Re: Docket No. 70-925; License No. SNM-928
Survey of Sediment/Spoils Mixture from 1206 Drainage in Subarea B

ATTACHMENT 1
PROPOSED REVISED DRAWINGS FROM APPENDIX J-2
FACILITY DECOMMISSIONING PLAN – REV 1

ATTACHMENT 2
PROPOSED REVISIONS TO SECTION 8.2.4
FACILITY DECOMMISSIONING PLAN – REV 1

BMCD-GWREMED-C002
BMCD-GWREMED-C004

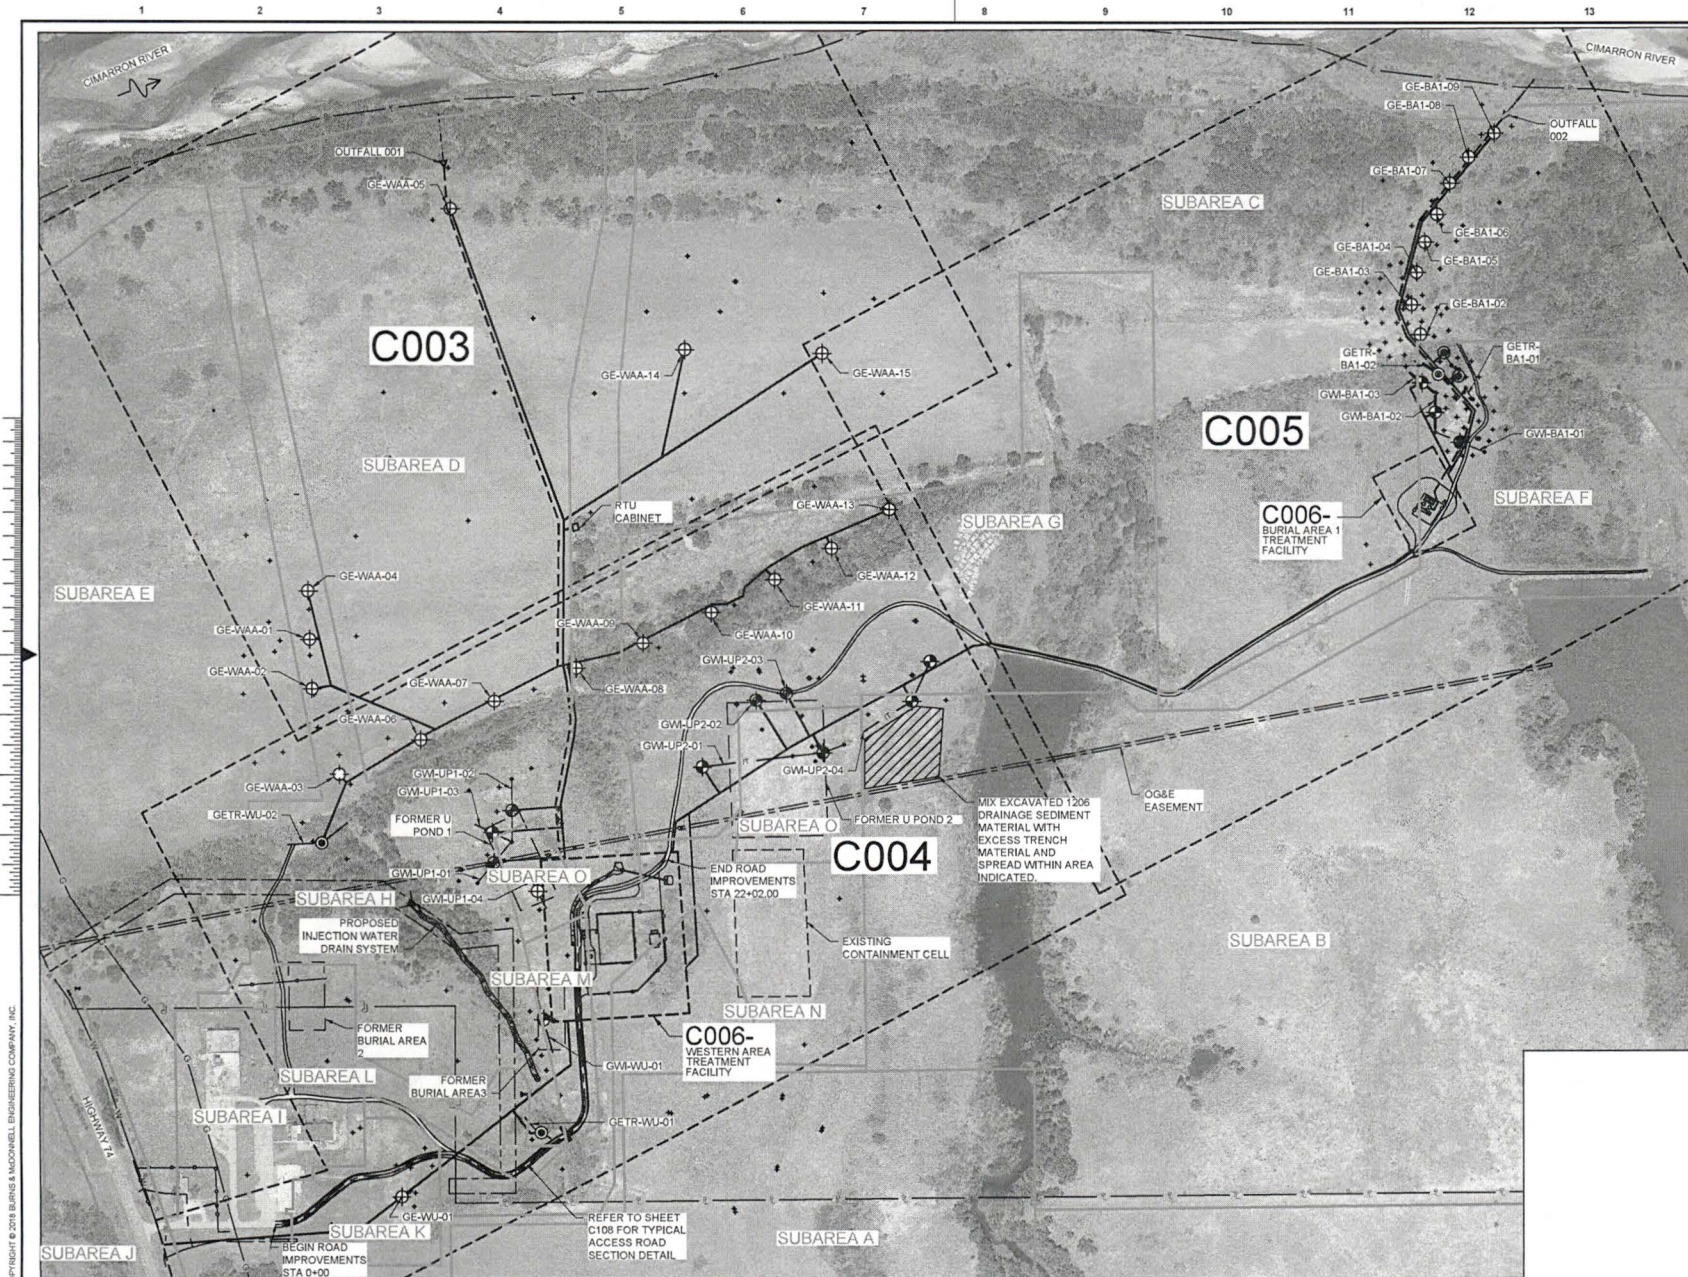
The radiological survey described herein is expected to confirm that no sediment/spoils mixture exceeding the Criterion will be present in Subarea B, and Subarea B will remain released for unrestricted use. Drawings BMCD-GWREMED-C002 and BMCD-GWREMED-C004 from Appendix K2 of the DP have been revised to show the location of the laydown area and are provided as Attachment 1 to this letter.

Drawing BMCD-GWREMED-C002 includes the outlines of the Subareas for your convenience. Proposed revisions to the "1206-NORTH" part of Section 8.2.4 of the DP, providing additional information on the management of sediment removed from the 1206 Drainages, and referencing the survey plan described herein, are provided as Attachment 2 to this letter.

To facilitate the transfer of seepage from WU-BA3 to GETR-WU-02, a slotted pipe will be installed in the east branch of the 1206 drainage to convey the seepage directly to the transition zone material in which GETR-WU-02 is constructed. The same non-reactive gravel used in the construction of injection and extraction trenches will be used as backfill to maintain the integrity of the drainage channel and protect the slotted pipe. The extent of sediment excavation and the installation of the slotted pipe and gravel backfill are shown on Drawing C004 (Appendix J-2).
